**RM03**

DISK DRIVE

PROCESSOR TYPE 10, 11, VAX

Engineering Change  
Order Log

Fig 1

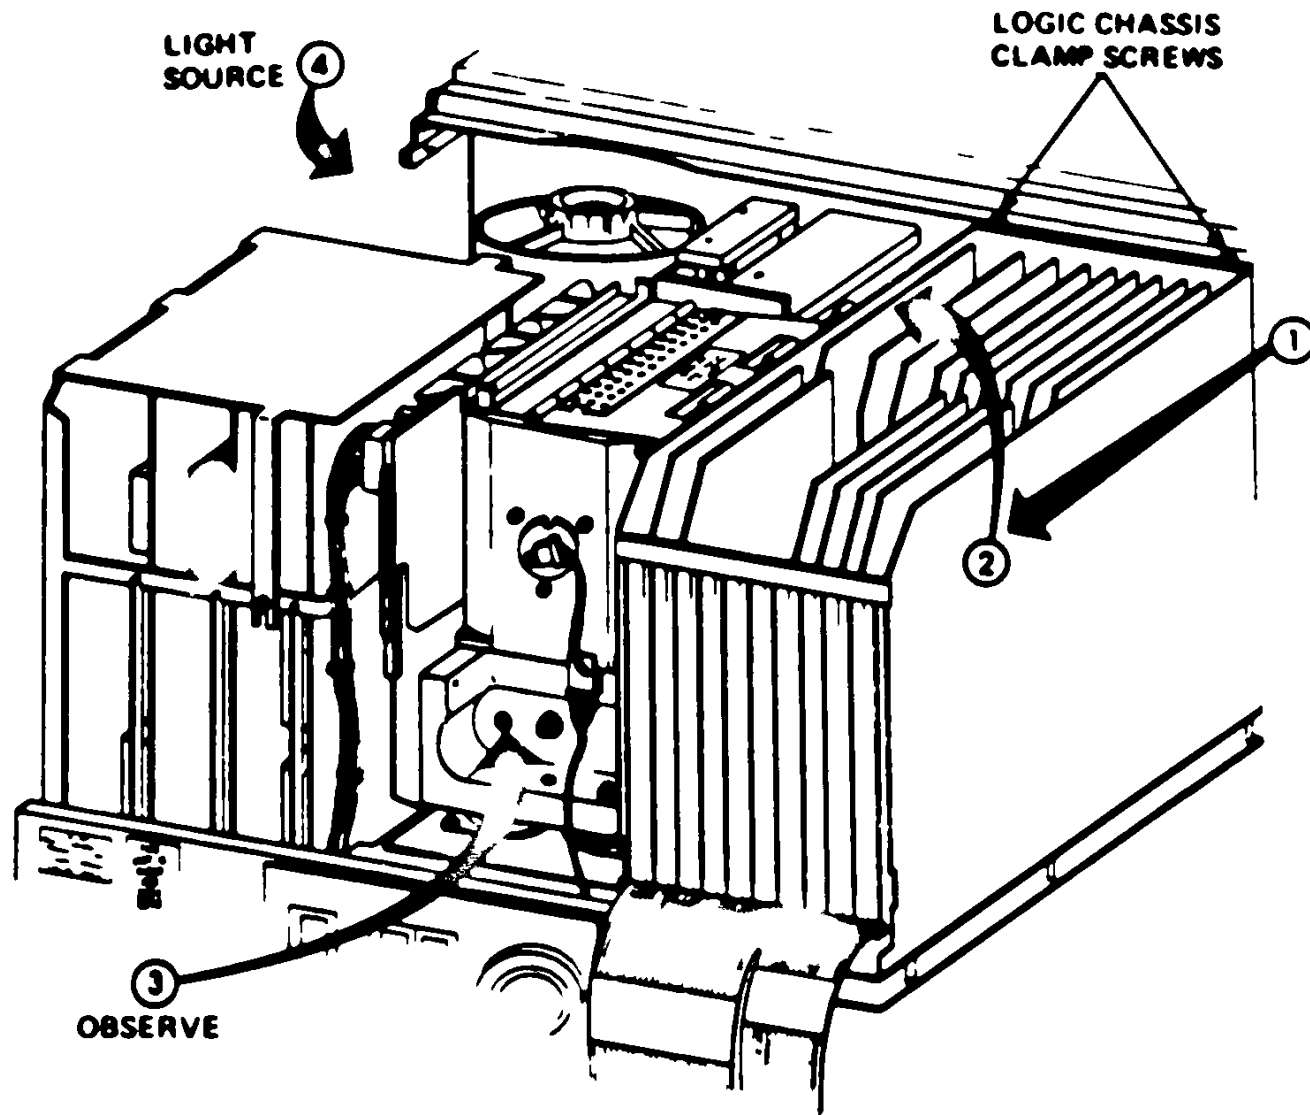
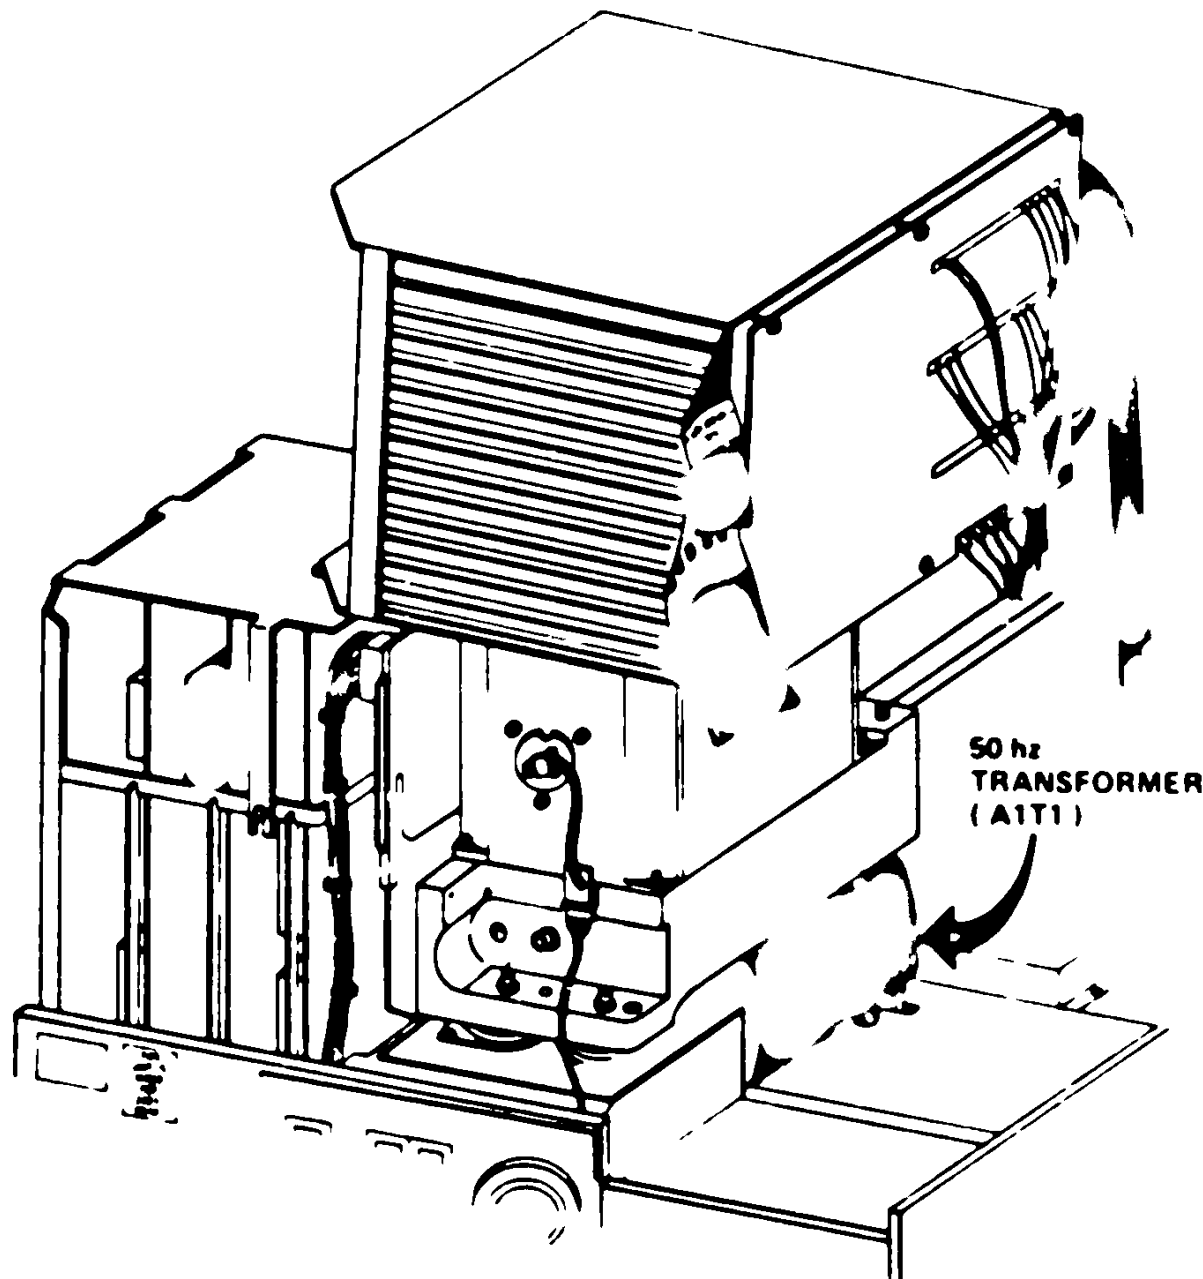
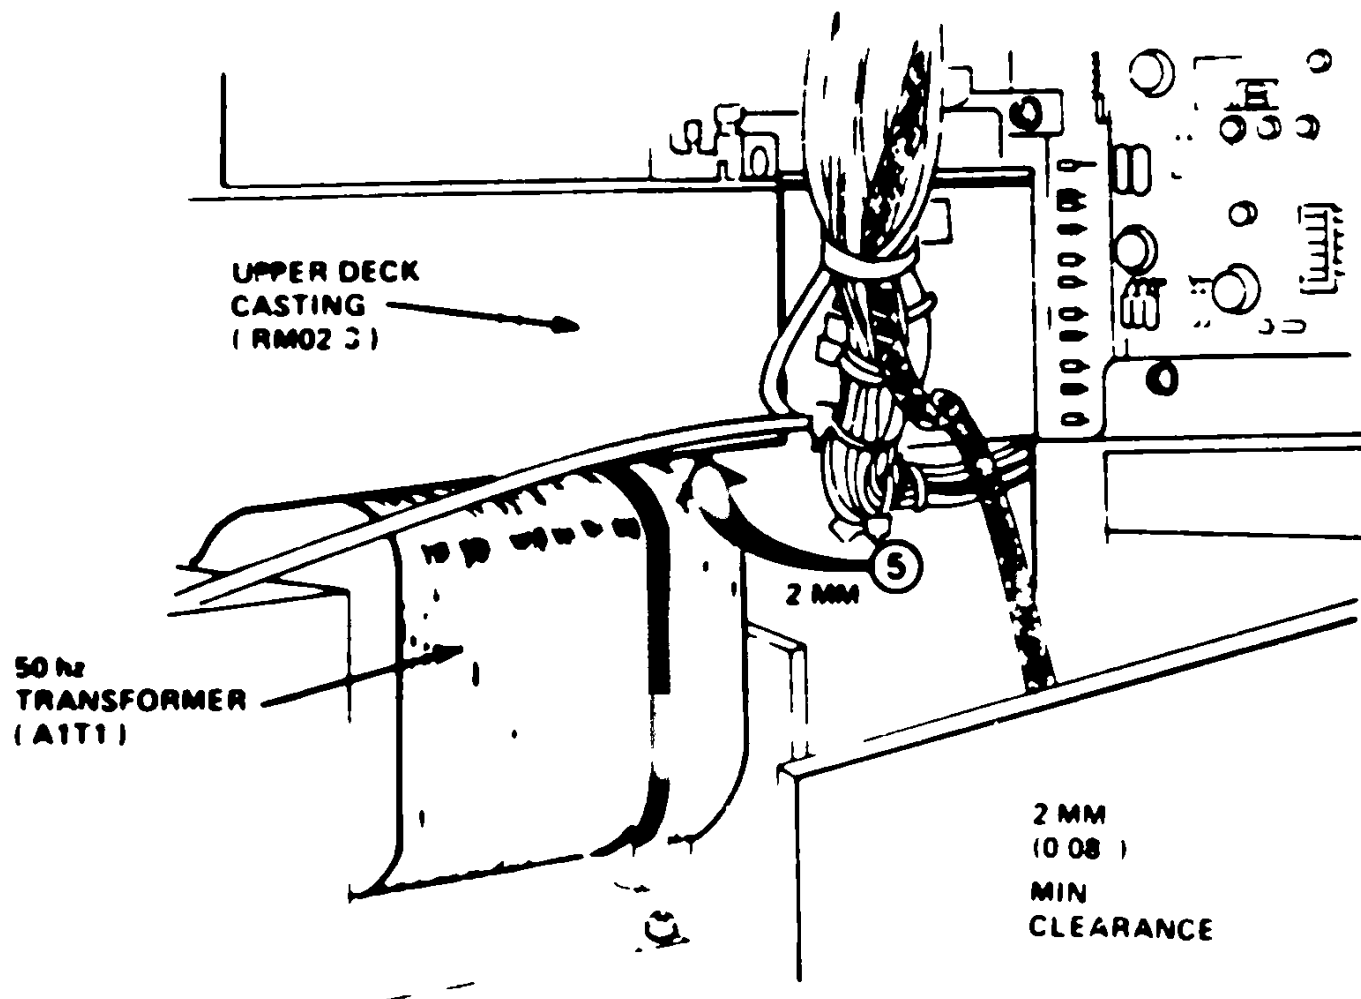
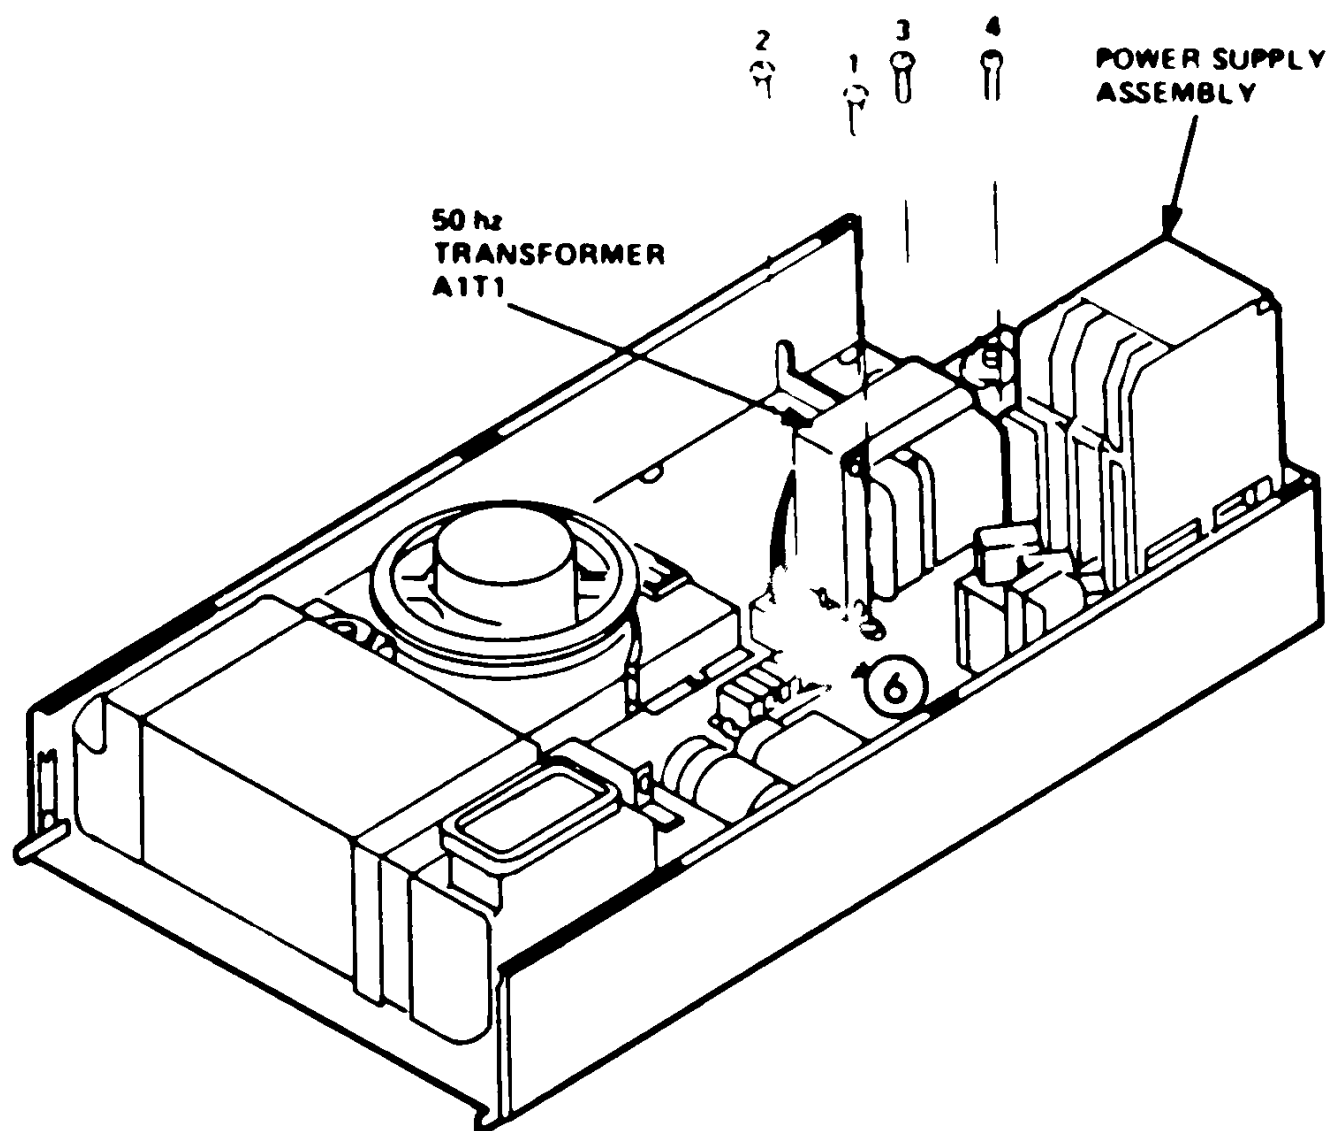
- 1) Power down the drive and disconnect the AC power source.
- 2) Remove the top cover assembly.
- 3) From the rear of the drive, loosen the logic chassis clamp screws (see figure 1).
- 4) CAREFULLY slide the logic chassis (on its hinges) towards the rear of the drive and then up and to the left (counterclockwise) into the maintenance position (arrows 1 & 2, figure 1).
- 5) Locate the main 50hz transformer (A1T1) as shown in figure 2.
- 6) A closer view of the transformer is shown in figure 3.
- 7) The critical area of clearance is noted by arrow 5, figure 3. Check to be sure that there is sufficient clearance between the transformer and the upper deck chassis. A minimum of 2mm (.08") clearance is required. A flashlight and feeler gauge set may be required.

8) Loosen the transformer mounting screws (#1, #2, and #3 in figure 4). Screw #4 is unaccessible at this time.

- 9) Rotate the transformer (using screw 4 as the pivot point) in the direction noted by arrow 6 in figure 4 until the required clearance is obtained. Since screw #4 is still tightened, the transformer may have to be lightly "tapped" to perform this step. If the transformer will not move, the 4th screw will have to be loosened. This screw is accessible by first removing the power supply assembly (figure 4).

- 10) After readjusting the transformer, retighten the transformer mounting screws (1,2,3,4 in figure 4).
- 11) With the upper deck in its LOWERED POSITION, check for adequate clearance on the "other" side of the transformer. This will be the side of the transformer closest to the power supply. This area may be observed by looking through the hole in the rear of the positioner (arrow 3, figure 1) and applying sufficient light (with a flashlight) as shown by arrow 4 in figure 1. Assure there are no pinched wire harnesses and no chance of damage due to contact between the transformer or transformer winding assembly and other surrounding components or chassis.

**FIGURE 3 VDE RM05 AC POWER CABLE**

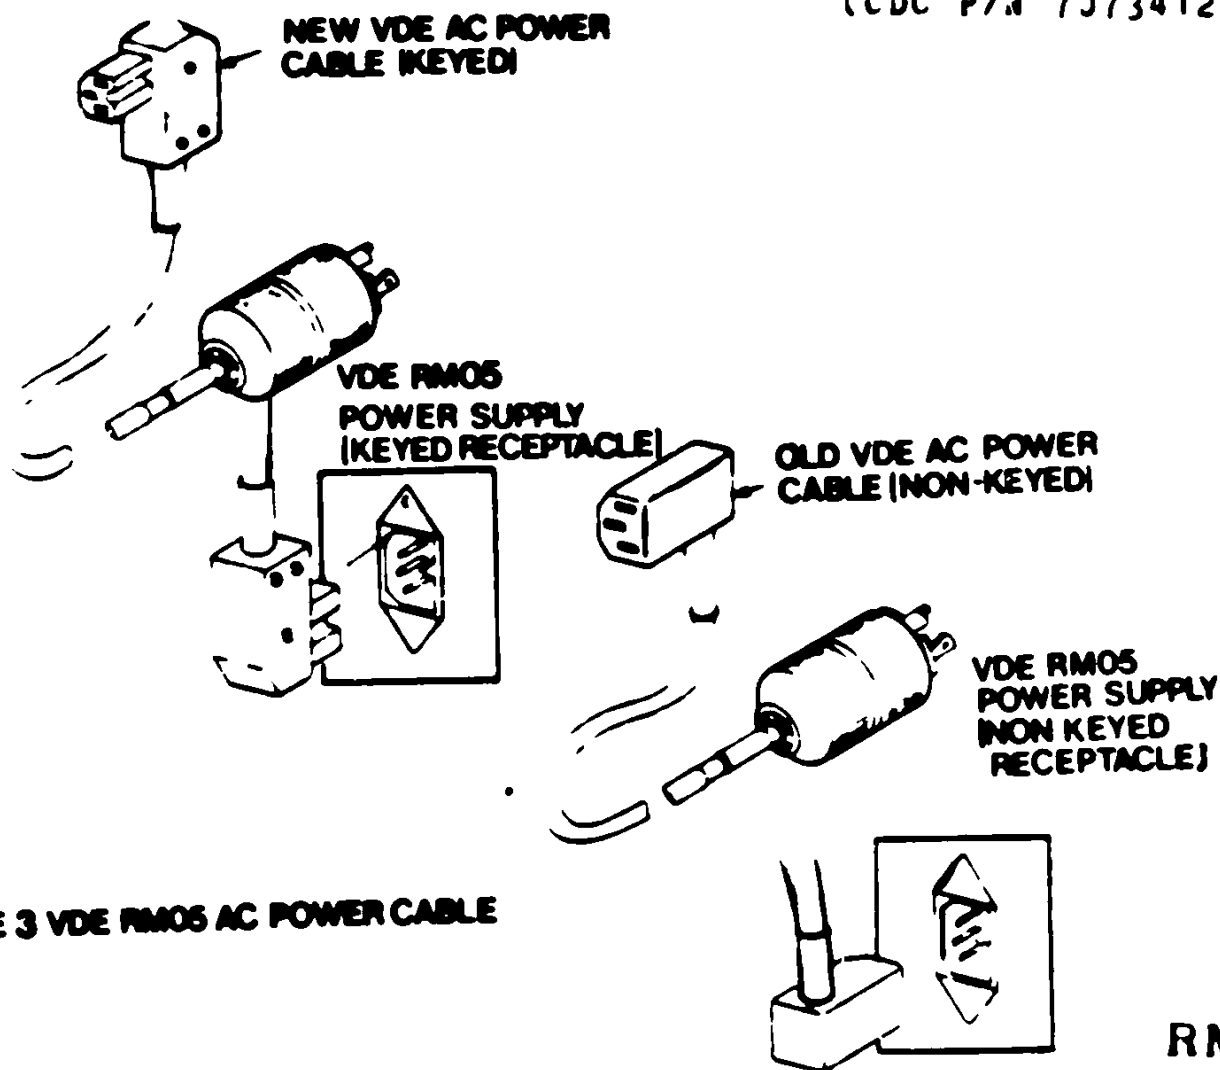
The new AC power cables may be used with any of the VDF power supplies, but the old AC power cables will not fit into the new VDF power supplies with the vendor part numbers 73133108 and the above. An example of the new "keyed" cable is shown in Figure 3.
